HISTORIC AND DESIGN REVIEW COMMISSION

May 20, 2020

HDRC CASE NO: 2020-194
ADDRESS: 515 NOLAN ST
LEGAL DESCRIPTION: NCB 546 BLK 19 LOT E 7 FT OF 13 & W 46.5 FT OF 14
ZONING: R-6, H
CITY COUNCIL DIST.: 2
DISTRICT: Dignowity Hill Historic District
APPLICANT: Sergio Medellin Jr.
OWNER: 515 NOLAN ST SERIES
TYPE OF WORK: Addition; siding; window repairs; garage
APPLICATION RECEIVED: April 19, 2020
60-DAY REVIEW: Not applicable due to City Council Emergency Orders
CASE MANAGER: Huy Pham
REQUEST:

The applicant is requesting a Certificate of Appropriateness for approval to:

FRONT ELEVATION (NO CHANGES)

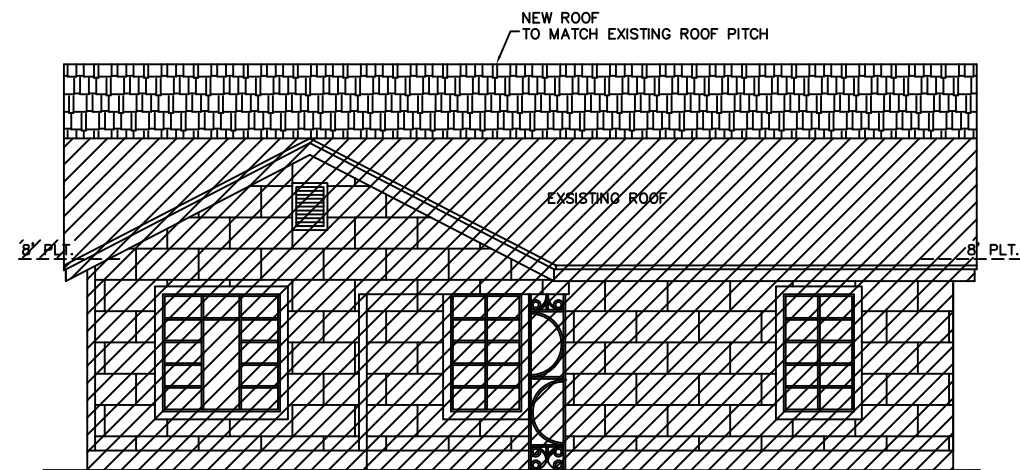
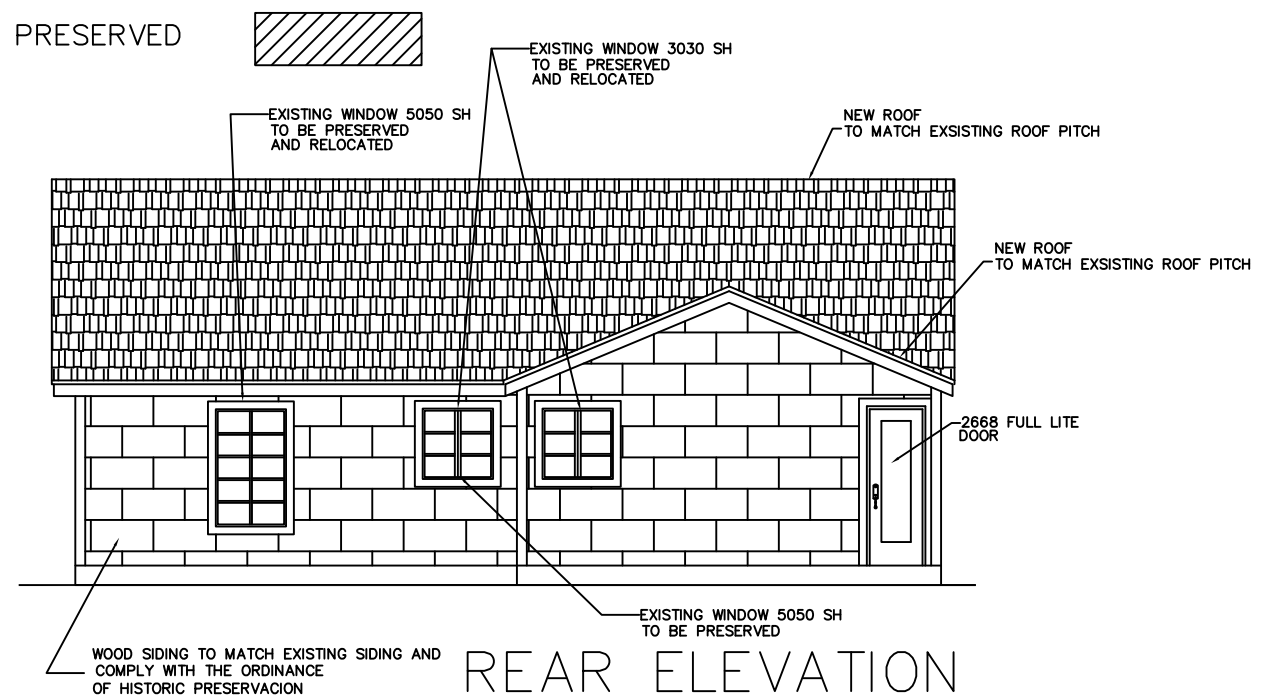
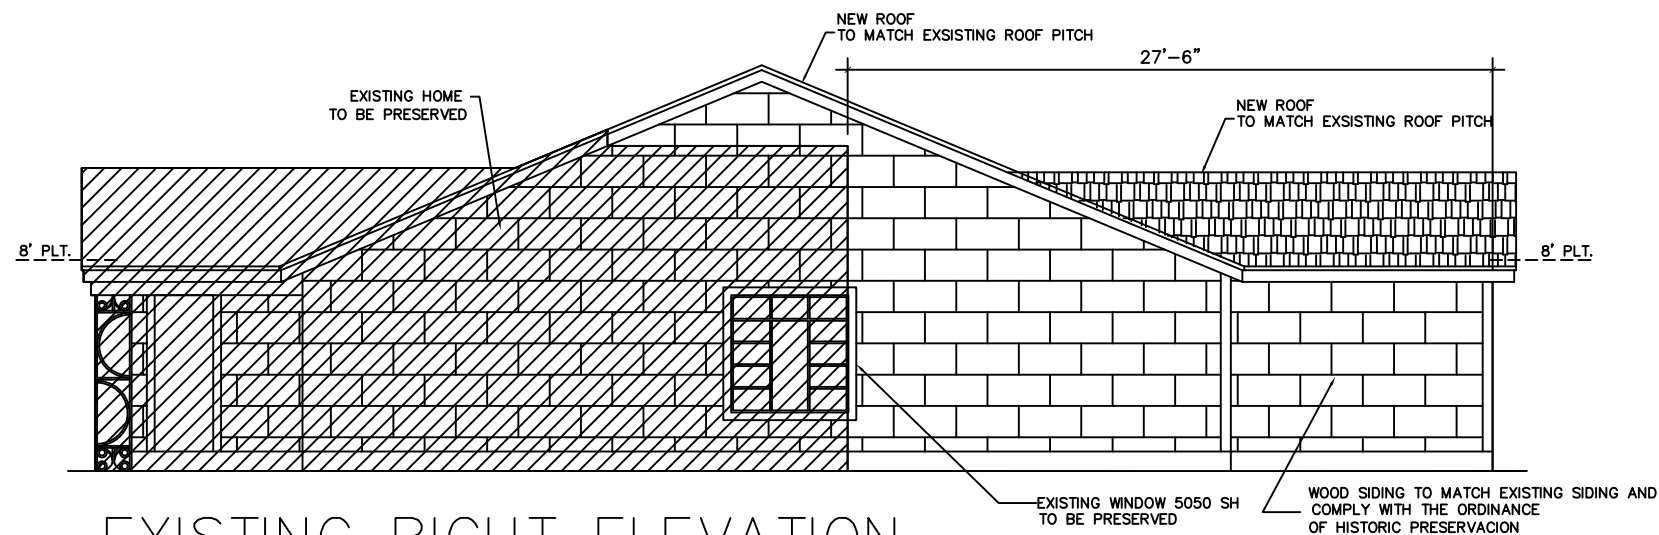
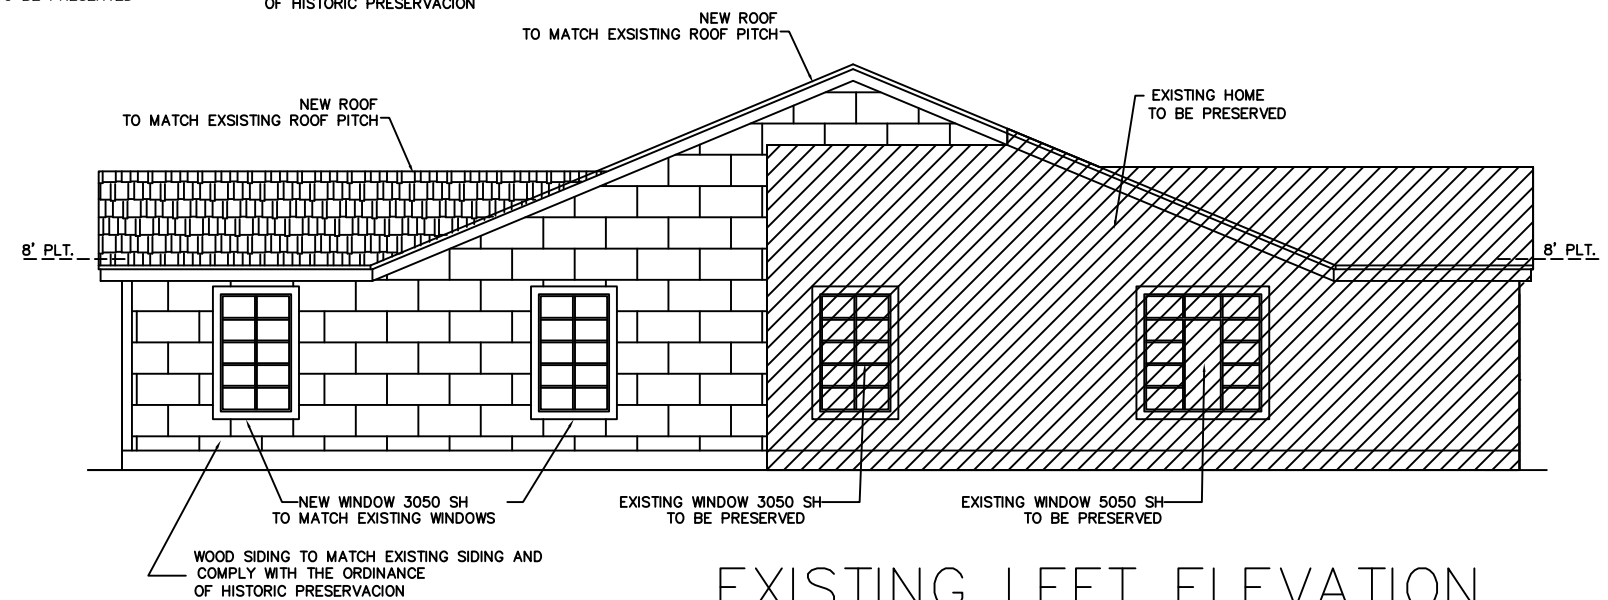
proposed the use of wood lap siding. Staff finds that the design lacks a transition from new and old forms and is inconsistent with the Guidelines; the applicant should incorporate a setback between new and old wall planes, utilize different but related siding materials, and/or include a vertical trim piece between forms.

- i. **HEIGHT** – The primary historic structure features a maximum height of 13'-3" at gable ridge. The applicant has proposed to raise the height of the existing gable roof to 17'-3 ½" to accommodate the rear addition. Per the Guidelines for Additions 1.B.v., generally, the height of new additions should be consistent with the height of the existing structure; the maximum height of new additions should be determined by examining the line-of-sight or visibility from the street; addition height should never be so contrasting as to overwhelm or distract from the existing structure. The submitted line-of-sight study notes that the addition would be visible from the front right-of-way. Staff finds that the total height and roof form of the original structure should not be altered and that the addition should be match or is subordinate to the historic structure in height.

- i. TRANSITION - That the design incorporates a setback between new and old wall planes, utilize different but related siding materials, and/or include a vertical trim piece between forms.
- ii. HEIGHT - That the total height and roof form of the original structure should not be altered and that the addition should be match or is subordinate to the historic structure in height.
- iii. WINDOWS - That the proposed new windows (JELD-WEN V-4500) are inconsistent with the *Standard Specifications for Windows for New Construction* by including nailing fins, faux divided lites, and depth; an aluminum or aluminum-clad wood casement window with true divided lites would be more appropriate.
- iv. GARAGE DOORS – That an appropriate garage door design or product is submitted to staff.

PROPOSED ROOF

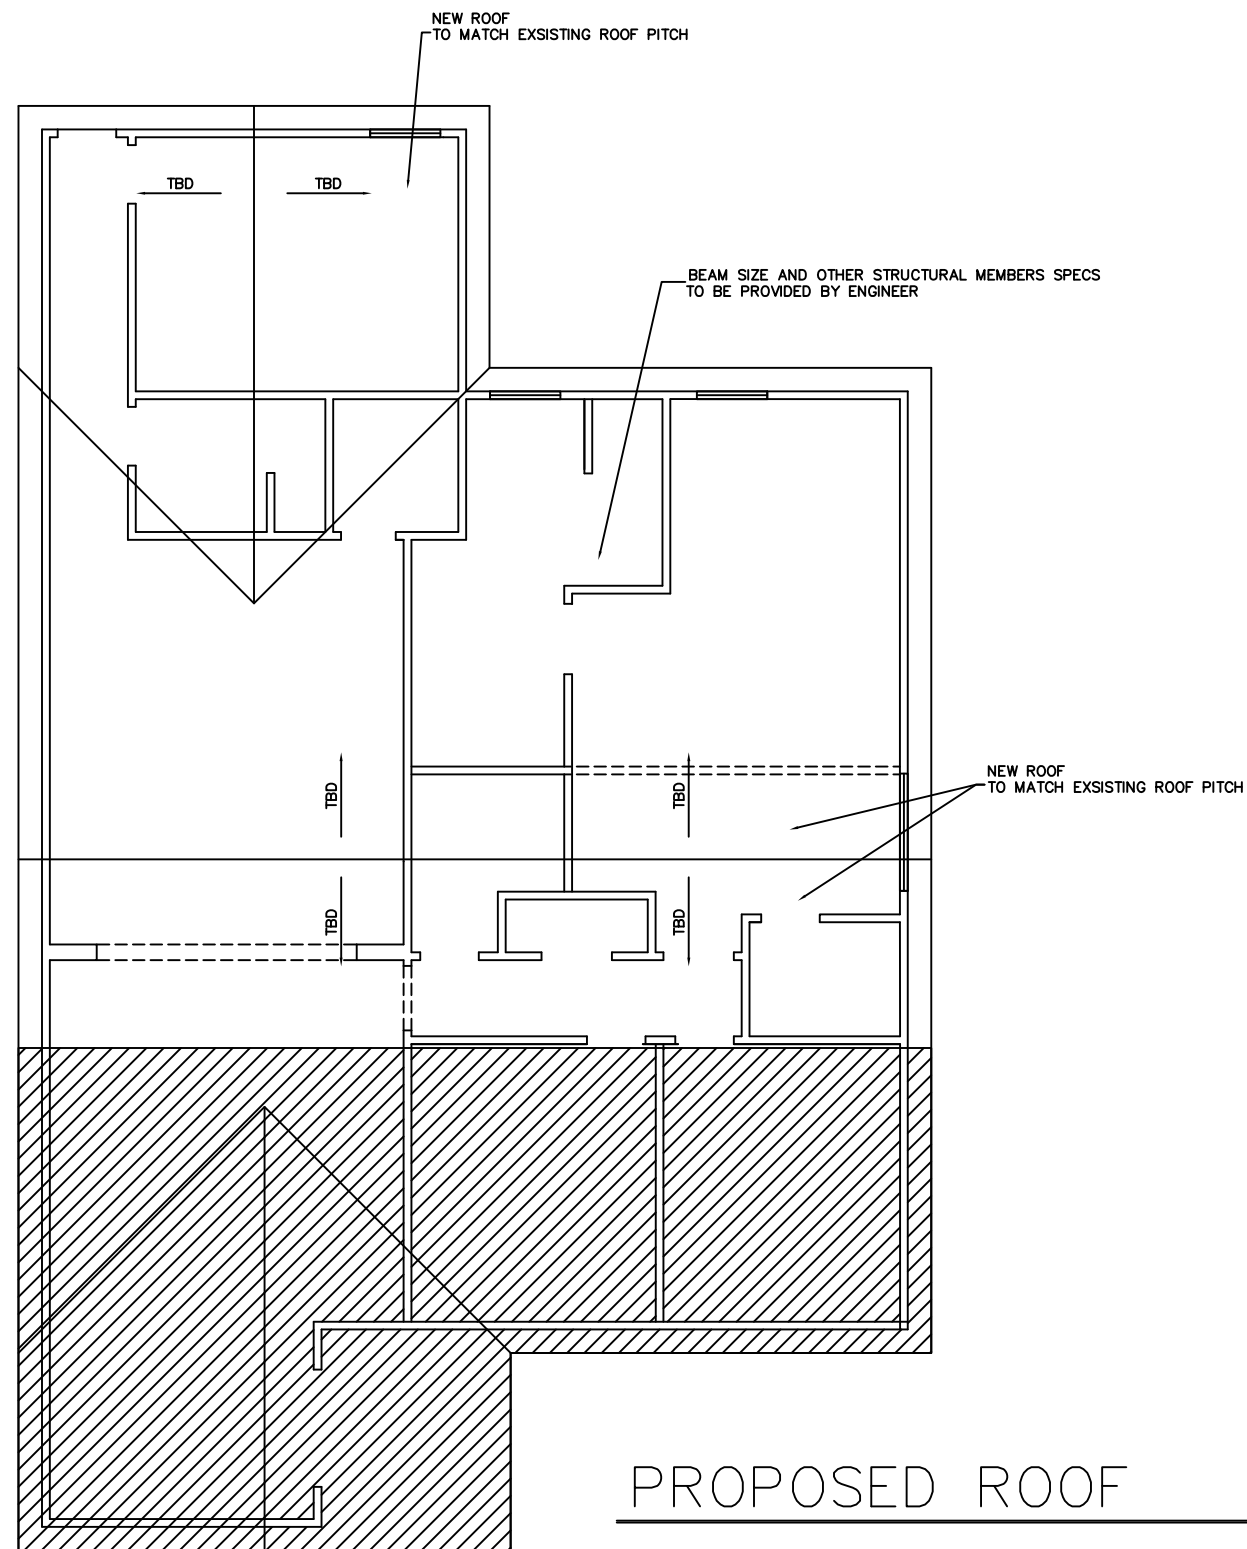
- e. ROOF FORM – The proposed addition features hipped roofs continuing from the existing gable roof. Per the Guidelines for Additions 1.A.iii., applicants should utilize a similar roof pitch, form, overhang, and orientation as the historic structure for additions. Staff finds that proposed new roof forms are consistent with the Guidelines and relates to the primary historic structure.

EXISTING WOOD GARAGE FLOOR PLAN

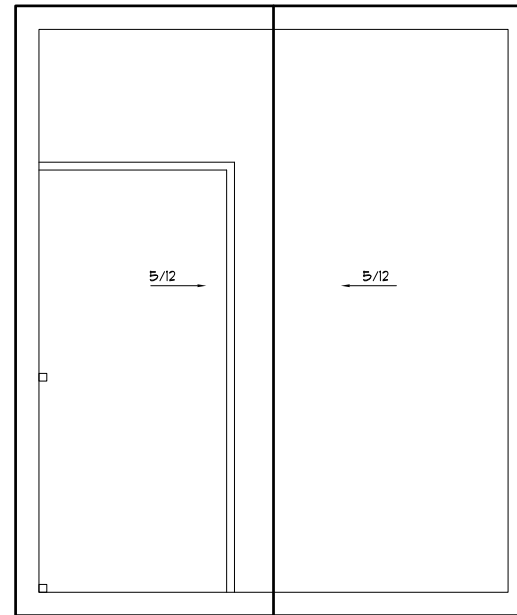
- o. **ACCESSORY STRUCTURE** - The applicant has proposed modifications to the rear accessory structure including partially enclosing the inset porch, installation of a new vinyl casement window, and garage door replacement. Per the Guidelines for Exterior Maintenance and Alterations 9.B.i., applicants should ensure that replacement

garage doors are compatible with those found on historic garages in the district (e.g., wood paneled) as well as with the principal structure; when not visible from the public right-of-way, modern paneled garage doors may be acceptable. While garage door replacement is appropriate, the applicant has not submitted a door product or design and should submit to staff prior to approval. Staff finds the proposed enclosure appropriate if a vertical trim piece is included to distinguish between old and new forms. Staff finds that the proposed new window is inconsistent with the *Standard Specifications for Windows for New Construction* by including nailing fins, faux divided lites, and depth; an aluminum or aluminum-clad wood casement window with true divided lites would be more appropriate.
